VIRGINIA ELECTRIC AND POWER COMPANY
SURRY POWER STATION UNITS 1 AND 2
SIX-MONTH STATUS REPORT IN RESPONSE TO MARCH 12, 2012 COMMISSION
ORDER MODIFYING LICENSES WITH REGARD TO REQUIREMENTS FOR
MITIGATION STRATEGIES FOR BEYOND-DESIGN-BASIS EXTERNAL EVENTS
(ORDER NUMBER EA-12-049)

**Six Month Status Report for the Implementation of Order EA-12-049
Order Modifying Licenses with Regard to Requirements for Mitigation Strategies for
Beyond-Design-Basis External Events**

**Surry Power Station Units 1 and 2
Virginia Electric and Power Company (Dominion)**

FIGURE 3 (AUGUST 2013 UPDATE)
CORE COOLING AND DECAY HEAT REMOVAL
PRIMARY AND ALTERNATE MECHANICAL CONNECTIONS
SURRY POWER STATION

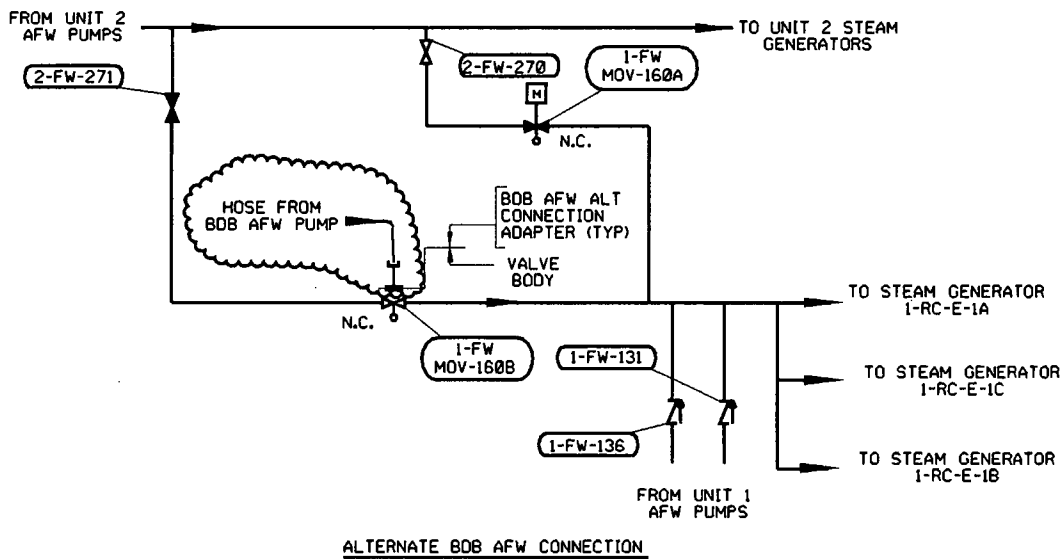
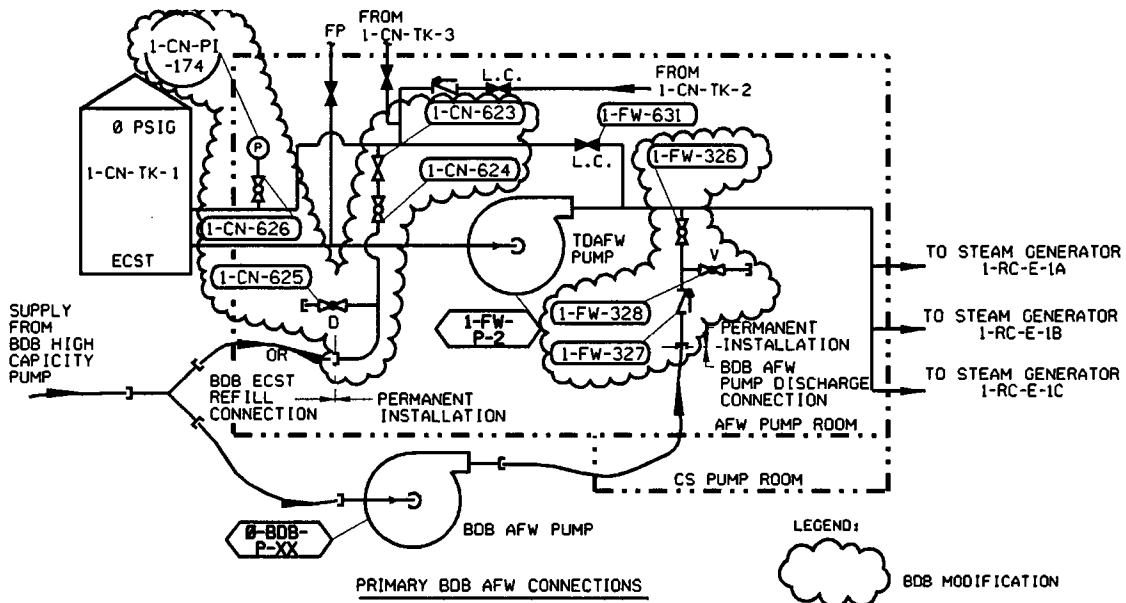
- a) Details of the alternate connection strategy for Auxiliary Feedwater (AFW) injection, as described in Section B.2 – PWR Portable Equipment Phase 2 and shown on OIP Figure 3, have changed for Surry Units 1 and 2. The tie-in locations at valve 1-FW-57 (Unit 1) and 2-FW-57 (Unit 2) will no longer be used as the alternate AFW injection connections. The re-located connections described below are more readily accessible and serve the same function in the alternate strategy.

For Unit 1, the bonnet assembly of the AFW cross-connect isolation motor-operated valve (MOV) 1-FW-MOV-160B, located in the Unit 2 AFW Pump House, will be removed and a flanged temporary hose connection adapter will be installed on the valve to support connecting the BDB AFW pump to the Unit 1 AFW cross-connect line. The location of 1-FW-MOV-160B allows for easy hose routing and is within a safety related structure.

For Unit 2, the bonnet assembly of the AFW cross-connect isolation MOV 2-FW-MOV-260B, located in the Unit 1 AFW Pump House, will be removed and a flanged temporary hose connection adapter will be installed on the valve to support connecting the BDB AFW pump to the Unit 2 AFW cross-connect line. The location of 2-FW-MOV-260B allows for easy hose routing and is within a safety related structure.

A revised OIP Figure 3 is attached. This figure represents the Unit 1 configuration only but is typical for both units.

FIGURE 7 (AUGUST 2013 UPDATE)
 BDB FLEX STRATEGY ELECTRICAL CONNECTIONS
 ONE LINE DIAGRAM
 SURRY POWER STATION

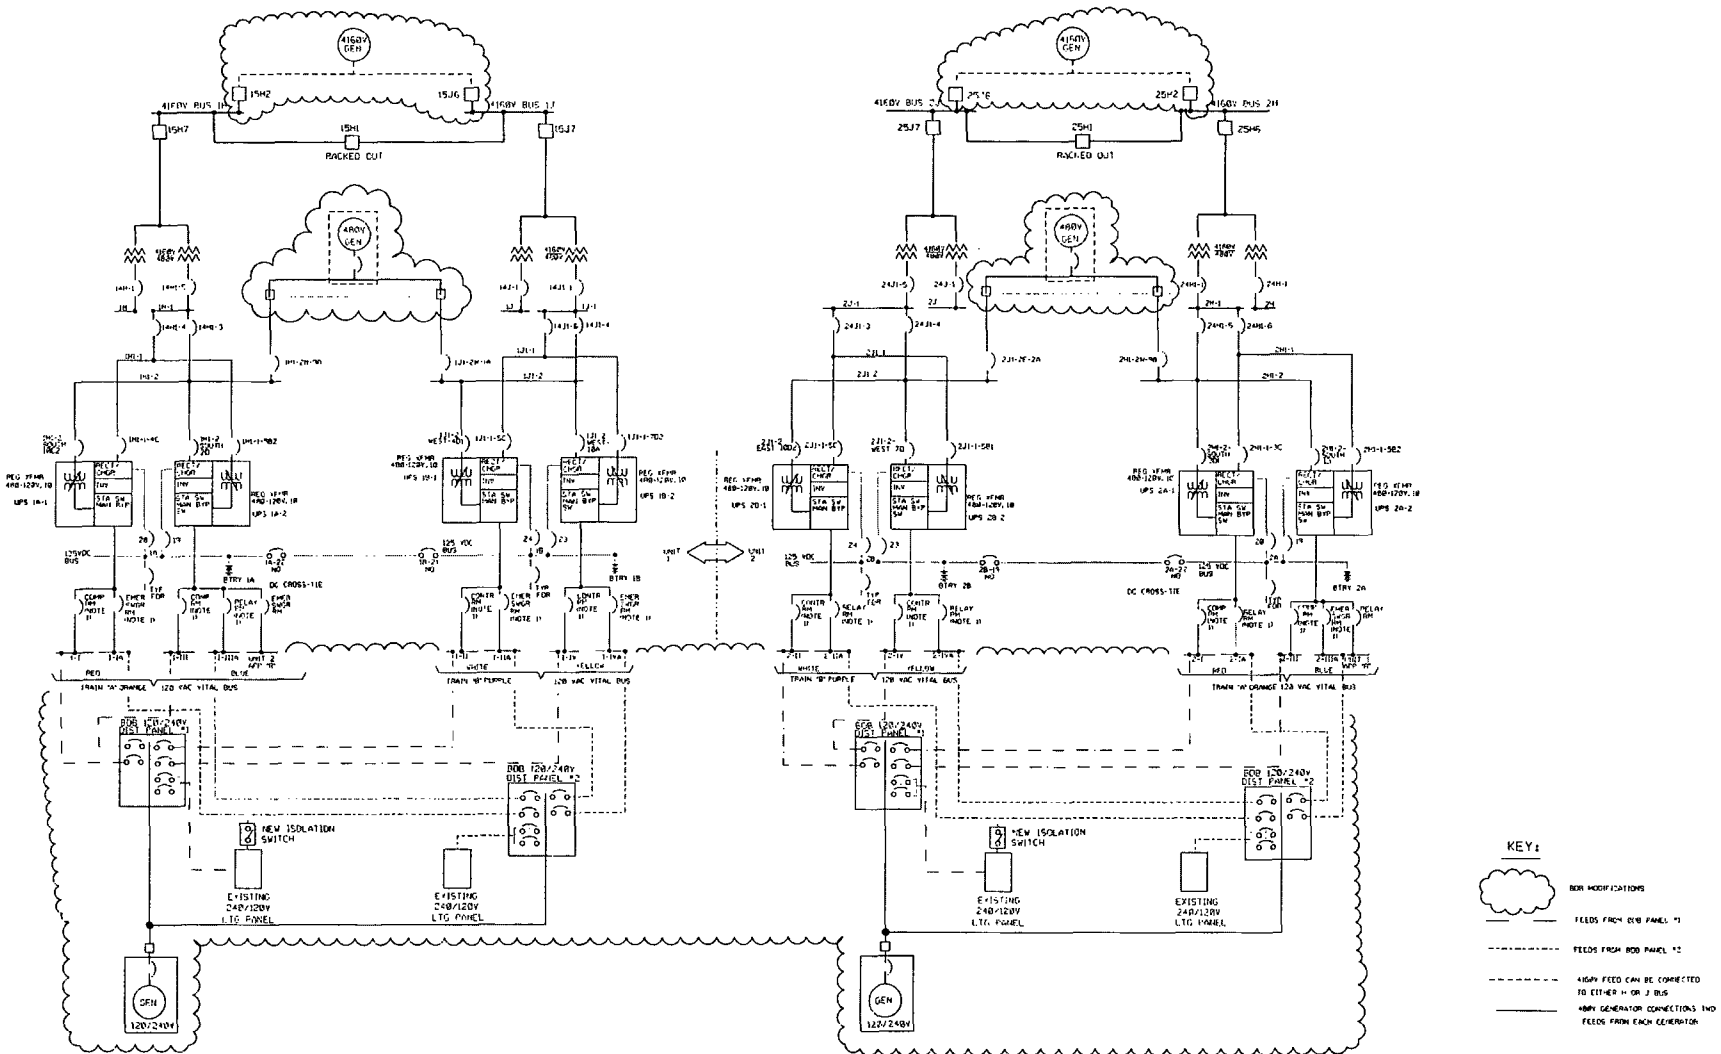
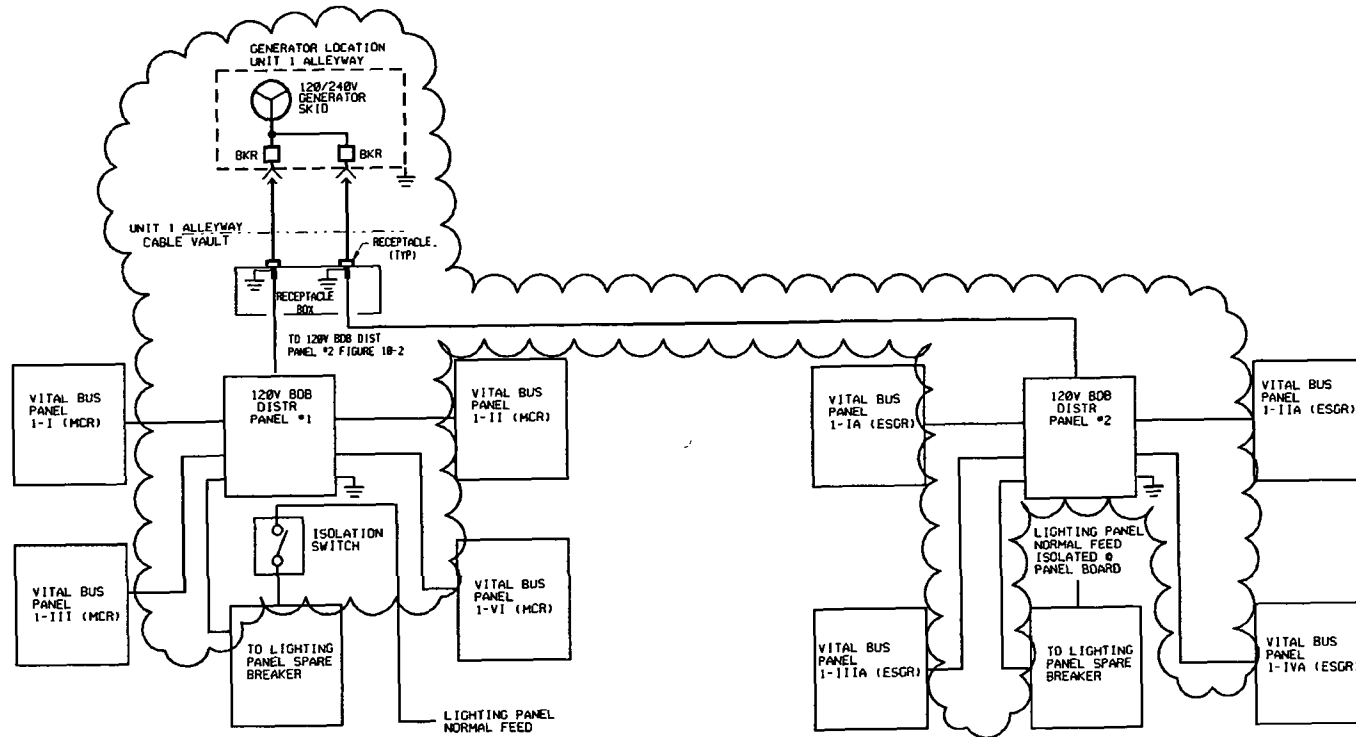
- b) Details of the strategy for the portable diesel generators (DGs) used to re-power the 120VAC vital bus circuits, as described in Section F1.2 – PWR Portable Equipment Phase 2, have changed for Surry Units 1 and 2. A single 120/240VAC DG per unit will be sized to accommodate the necessary electrical loads for that unit and will power both BDB distribution panels for that unit. Thus, the deployment of two 120/240 VAC DGs per unit as shown in Figure 7 of the previously submitted OIP is no longer being pursued, and a revised Figure 7 is attached. Figure 8 is not revised since the single 120/240VAC DG location is the same as the two DGs for each unit as stated in the OIP. Figure 9 was a typical schematic of the connections from one of two 120/240VAC DGs. A revised Figure 9 showing the current connections for the 120/240VAC DG (Unit 1 only) is attached. A spare 120/240VAC DG will be purchased; however, as stated in the OIP, the 480VAC DG is considered the alternate re-powering source for instrumentation.
